DEVELOPMENT REVIEW BOARD REPORT

CASE NUMBER/ PROJECT NAME	5-DR-2003#5 Jug N Barrel Wine Store		
LOCATION	14795 N Northsight Boulevard		
REQUEST	Request approval of a site plan and elevations for a single-story retail building in the Northsight Crossings Center.		
OWNER	Northsight Crossing LLC 702-784-7665	ENGINEER	Gilbertson Associates Inc. 480-607-2244
ARCHITECT/ DESIGNER	S K D Architecture 602-999-3140	APPLICANT/ COORDINATOR	Steve Kim S K D Architecture 602-999-3140
BACKGROUND	<p>Zoning.</p> <p>The property is zoned Central Business District (C-2). A retail store is permitted in this district.</p> <p>Context.</p> <p>The property is located within the Northsight mixed-use project along the Loop 101. Specifically, the subject property is a pad within the existing Northsight Crossing Shopping Center located on the west side of the site along Northsight Boulevard. The specific address of "Pad C" is 14795 N. Northsight Boulevard. The pad, currently undeveloped, is relatively flat and contains no vegetation. The main portion of the shopping center is built at this time. There are a variety of zoning districts that bound the property including office, industrial, and commercial.</p> <p

ENLARGED SITE PLAN
 5-DR-2003#5
 REV: 05/24/2005

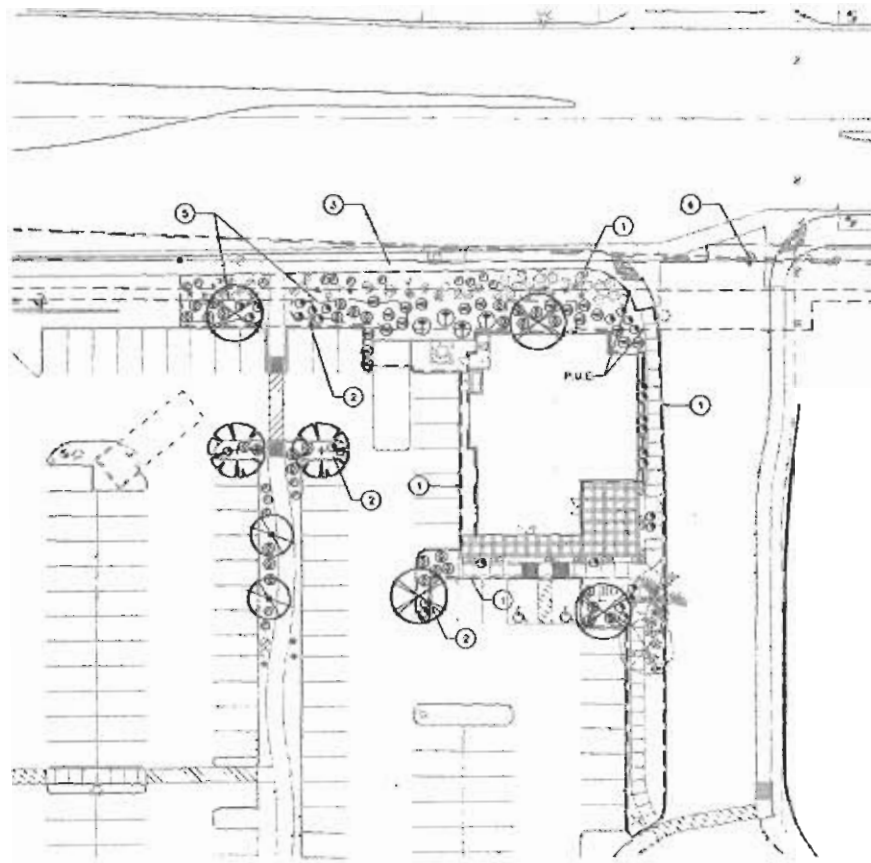
1. Except as required by the City Code of Ordinances, Zoning Regulations, Subdivision Regulations, and the other stipulations herein, the site design and construction shall substantially conform to the following documents:
 - a. Architectural elements, including dimensions, materials, form, color, and texture, shall be constructed to be consistent with the building elevations submitted by SKD with a staff receipt date of 12/17/2004.
 - b. The location and configuration of all site improvements shall be constructed to be consistent with the site plan submitted by SKD with a staff receipt date of 5/24/2005.
 - c. Landscaping, including quantity, size, and location of materials shall be installed to be consistent with the conceptual landscape plan submitted by SKD with a staff receipt date of 5/24/2005.
